Re: Initial Submission Review – Hilltop/Avelon - Comp Plan Amendment, Rezone, and Framework Development Plan
Application Number – **DA-2121-00**
Case Numbers: 2018-1002-00; 2018-2006-00; 2018-7004-00

First Submission Review Comments

PLACETYPE PLAN

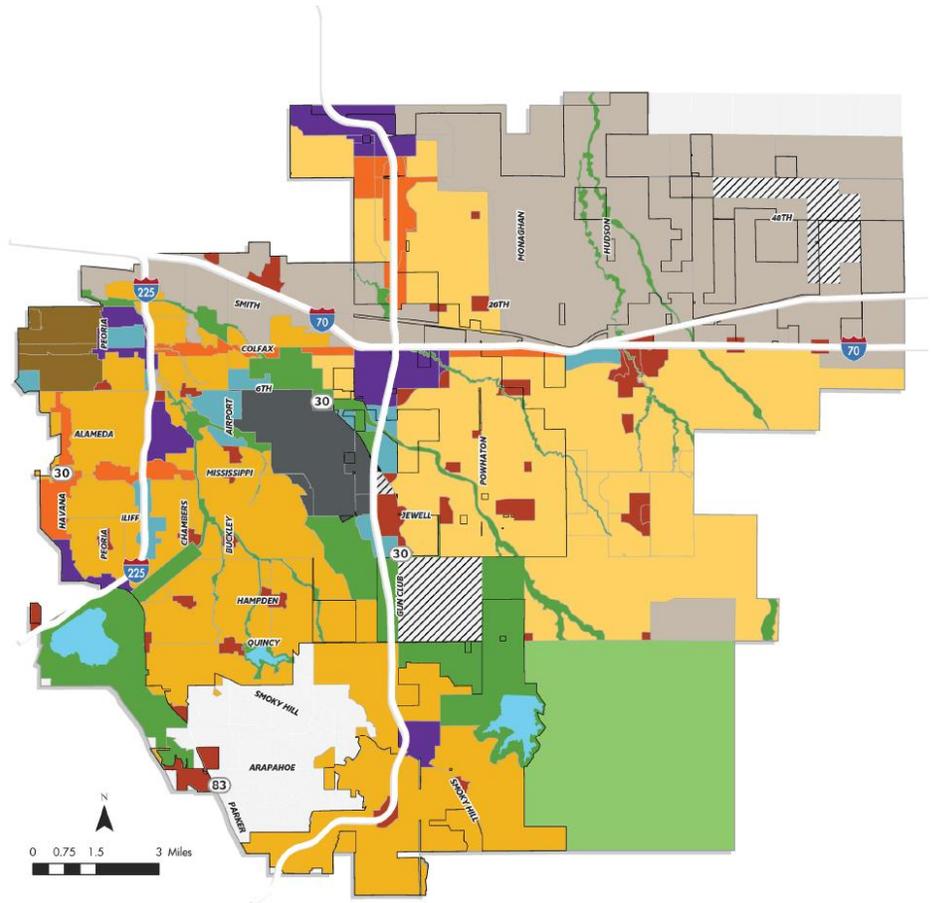
Based on the submission, the proposal would require both a comprehensive plan amendment and a rezone. Both of which are not supported at this time. Aurora Places, the city’s new comprehensive plan has denoted this area as a primary employment and “Urban District”.

Exhibit 12: Suggested Park Boundary

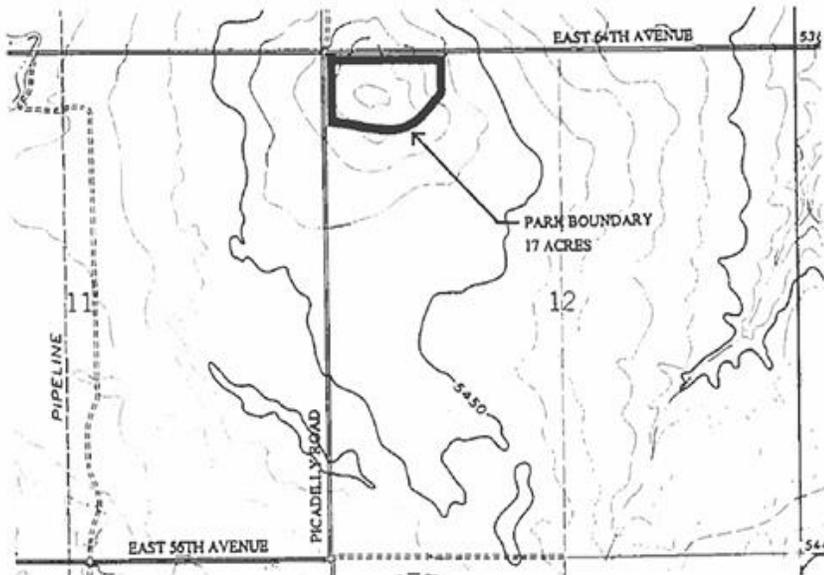
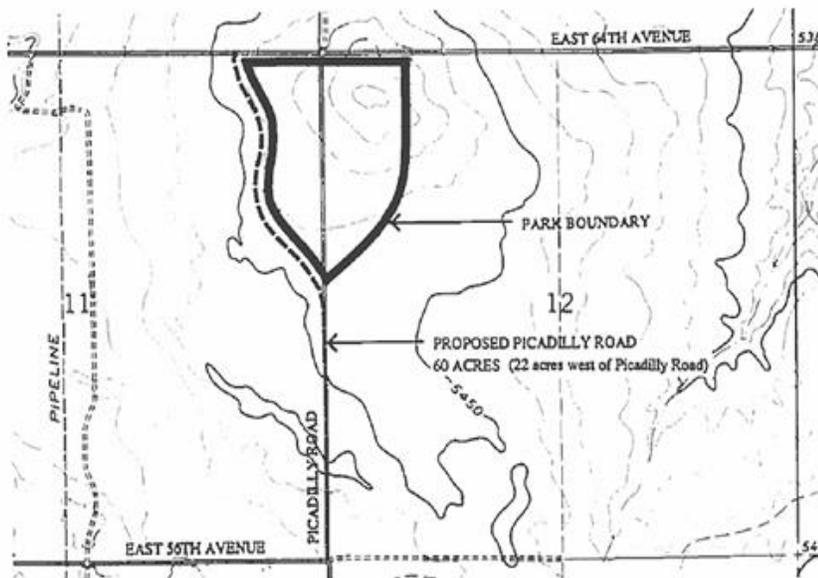
Regarding the size and location of the High Point Park referred to in multiple guidance documents, the legally accepted language comes from the January 1991 High Point Park View Corridor Analysis. The View Corridor Analysis is the fundamental document from which all other subject-specific guidance and Zoning Code Section 146-885 Mountain View Overlay District were derived. The location of the High Point Park is the SE corner of East 64th Avenue and Picadilly Road intersection (NW corner of subject property) encompassing the physical high point as it exists on the Hilltop / Avelon property today. The size of the High Point Park recommended by Exhibit 12 of the View Corridor Analysis clearly ranges between 17 acres and 60 acres. See graphic from View Corridor Analysis below:

17D. Tab 6 - Narrative

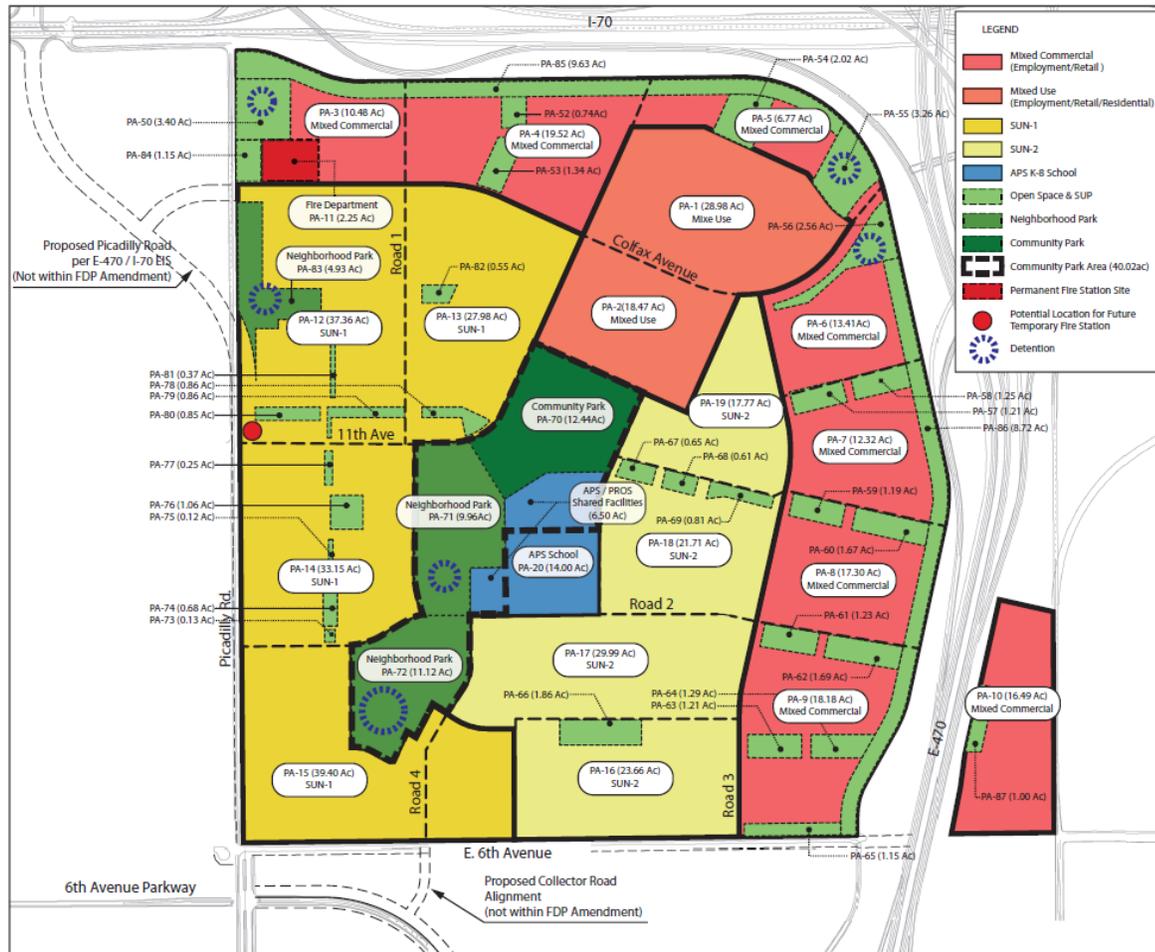
1. Include a description of the types of non-residential development. What kinds of uses are proposed, the density and proposed building area.
2. How many acres, specifically, are requesting to be rezoned to residential? How many acres will be open space and how many acres will remain ACORP?

3. Provide justification in the narrative using sections from the city zoning code explaining why this proposal should be considered for rezoning.
4. Existing utilities – discuss impacts from gas easement and power transmission lines and how FDP addresses the design challenge.

17G. Tab 9 – Open Space, Circulation and Village Plan

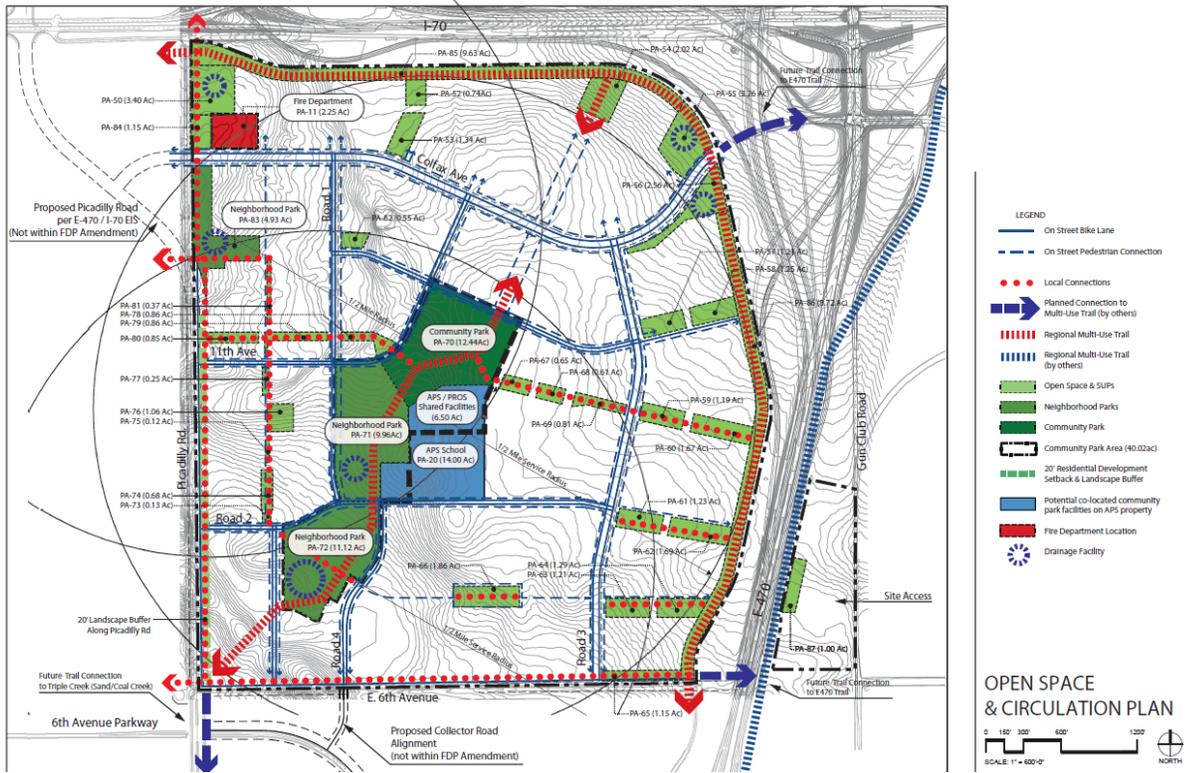
- 20 acre park dedication is required in the northwest corner of the site. Revise to show required amount of open space dedication from what is currently proposed.

- Several grade separated crossings of E-470 and I-70 via Collector roadways were identified in the NEATS. The crossings should be considered and reflected in the roadway and bicycle/pedestrian network for the development.
